Title: **Stage 1 Road Safety Audit and**

DMURS Quality Audit,

Proposed Residential Development, Blackglen Road, Sandyford Dublin 18.

Report reference: **2286R01**

Drawing Z040-OCSC-XX-XX-DR-C-0700 S4 P01, 4.5m carriageway.

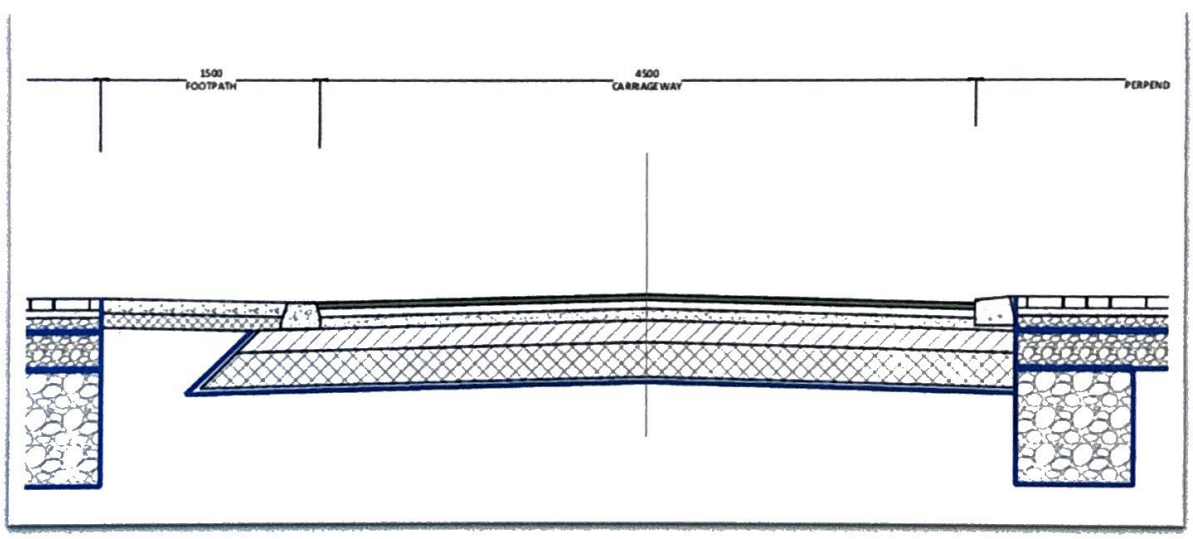
The roads that have a cross section of 4.5m carriageway and 1.5m footpath are narrow for two vehicles to meet and for cars and vans that are parked perpendicular to turn on.

The swept path analysis shows the footpath being used by turning vehicles. The roads are not shown to be shared streets.

The mounting of the footpath by reversing vehicles leads to risks to pedestrians and the narrow carriageway could lead to side-swipe collisions.

It is recommended that either the carriageways be widened or that shared streets be provided with a pedestrian refuge (of suitable width) rather than a footpath.

Paragraph No. in Safety Audit Report	Problem accepted (yes/no)	Recommended measure accepted (yes/no)	Alternative measures (describe)	Alternative measures accepted by Auditors (Yes/No)
4.1	No	No	These roads were designed as shared spaces but have not been labelled as such in the roads drawings. The drawings have been updated to indicate their status as shared spaces, with the reference to a 'footpath' changed to 'pedestrian refuge'.	Yes
4.2	Yes	Yes	N/A	
4.3	No	No	This access is proposed to be used as 'emergency access only' for vehicles. This access will be closed off with retractable bollards spaced less than 2m apart to prevent cars from entering. The bollards will be managed by the concierge, with the ability to lower the bollards in case of emergency. A note indicating the function of the access has been added to the roads drawings for clarity.	Yes
4.4	Yes	Yes

Drawing Z040-OCSC-XX-XX-DR-C-0110 S4 P01, Internal uncontrolled pedestrian crossing.

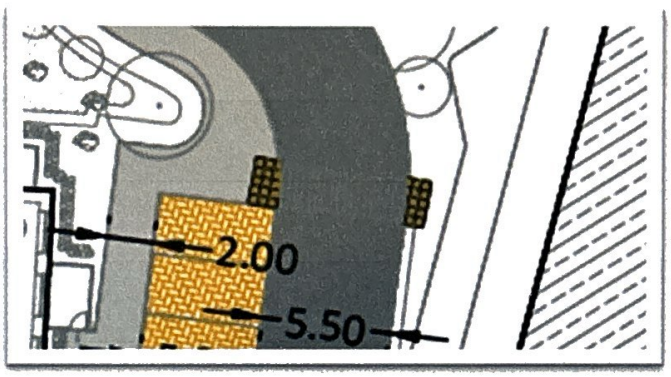
There is a proposed uncontrolled pedestrian crossing on the main access road from Blackglen Road which is located beside a perpendicular parking space. If a vehicle is parked in this space then the inter-visibility between a driver and a crossing pedestrian would be limited leading to possible collisions.

It is recommended that suitable inter-visibility be provided.

Drawing Z040-OCSC-XX-XX-DR-C-0110 S4 P01, Access onto Woodside Road.

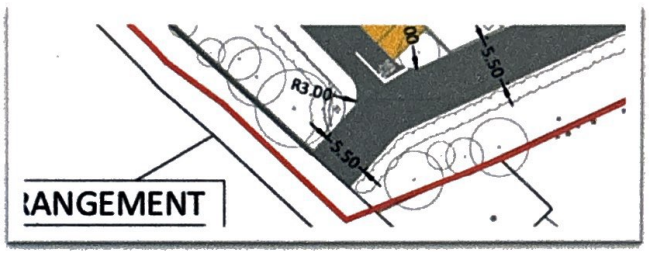
It is unclear what type of access is to be provided onto Woodside Road. A junction for vehicles with corner radii and visibility splays etc. have not been shown. If vehicles use this access it could lead to side-impact or rear-end collisions.

It is recommended that the Design Team clarify the use of this access and any restrictions on vehicles that may be provided.

Drawing Z040-OCSC-XX-XX-DR-C-0110 S4 P01, Visibility at side road junctions.

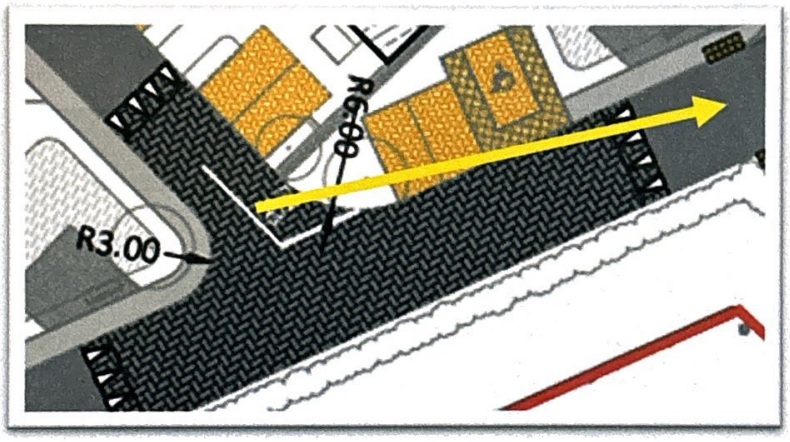
Visibility at the side road junctions may be obscured by parked vehicles which could lead to side-impact or rear-end collisions.

It is recommended that the visibility splays be kept clear or almost clear of parked vehicles.

Drawing Z040-OCSC-XX-XX-DR-C-0110 S4 P01, Access to/from disabled parking spaces.

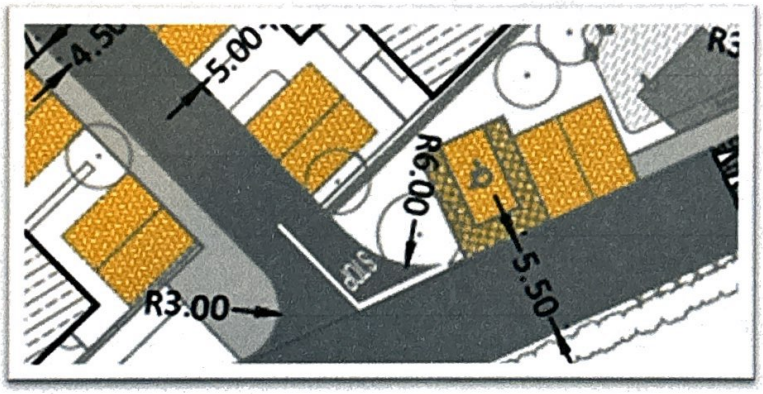
There is a proposed disabled parking space close to the junction of Road 6 and Road 1. There is no apparent footpath for users to enter to travel to their destination without having to enter the carriageway.

It is recommended that a footpath be provided for users of this and other disabled parking spaces.

Paragraph No. in Quality Audit Report	Problem accepted (yes/no)	Recommended measure accepted (yes/no)	Alternative measures (describe)	Alternative measures accepted by Auditors (Yes/No)
5.1	Yes	Yes		
6.1	Yes	Yes		
7.1	No	No	Cyclist will share the road with motorists within the development. The access design has been updated to tie in with the recently constructed infrastructure as part of the Blackglen Road Improvement Scheme. A toucan crossing is also being proposed just east of the access junction to allow pedestrians and cyclists to cross Blackglen Road safely.	Yes

Drawing Z040-OCSC-XX-XX-DR-C-0110 S4 P01, Road 1 Footpath continuity.

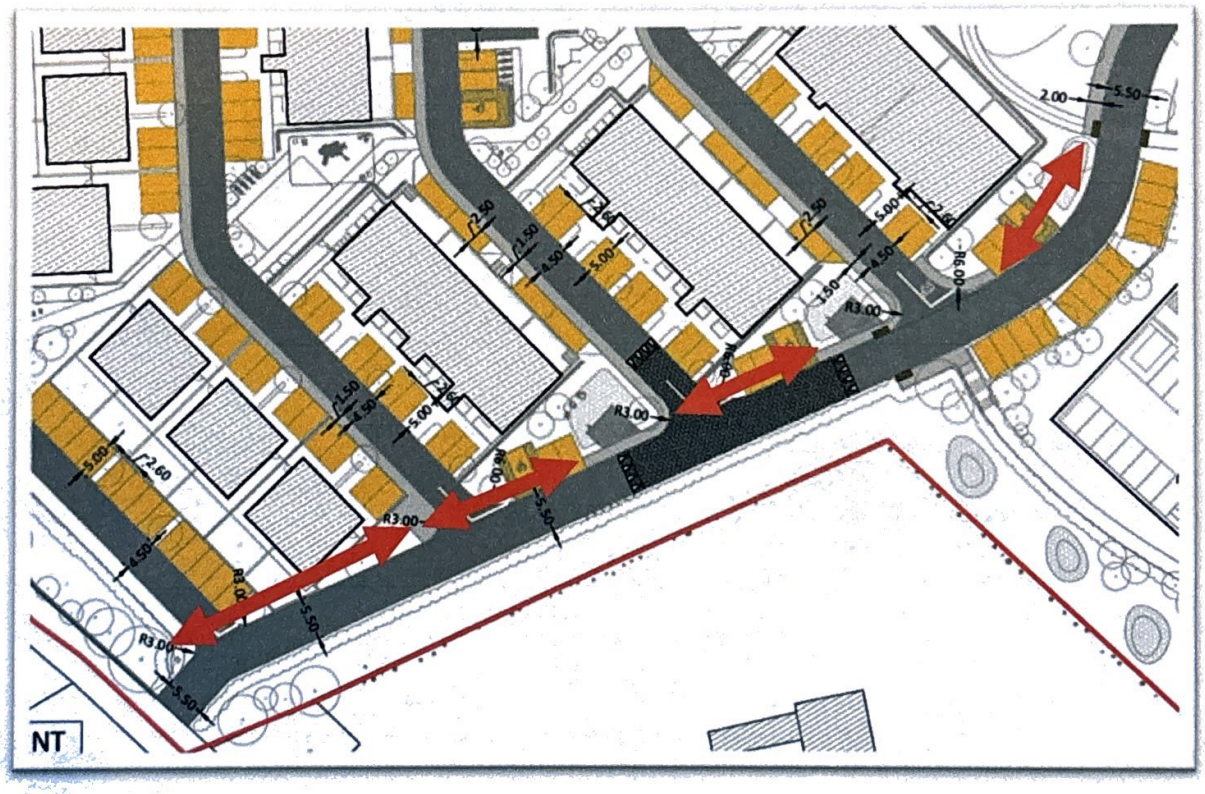
The footpath along Road 1 is not continuous at areas of perpendicular parking. This could lead to pedestrians travelling on the carriageway.

It is recommended that a continuous footpath, of suitable width, be provided along the entire road.

Drawing Z040-OCSC-XX-XX-DR-C-0110 S4 P01, Access onto Blackglen Road.

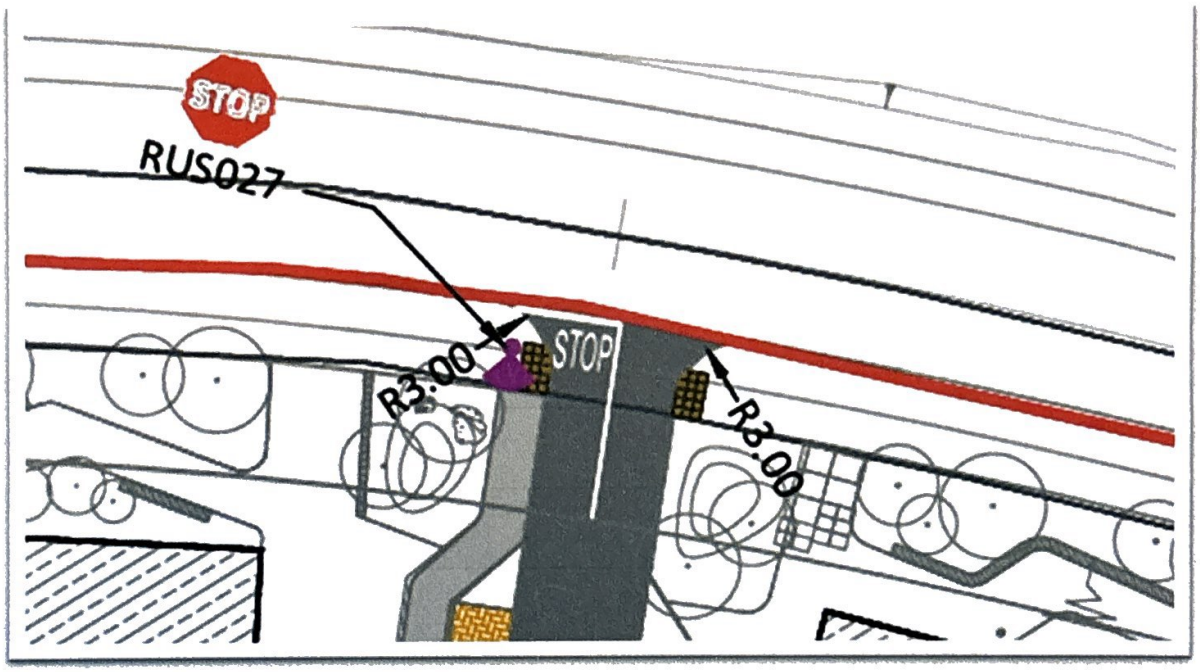
There are no cycle facilities to join with those on Blackglen Road. A lack of crossing facilities for cyclists can result in cyclists having to share space with pedestrians or general traffic resulting in a higher likelihood of collisions.

It is recommended that provision be made for turning cyclists on Blackglen Road.
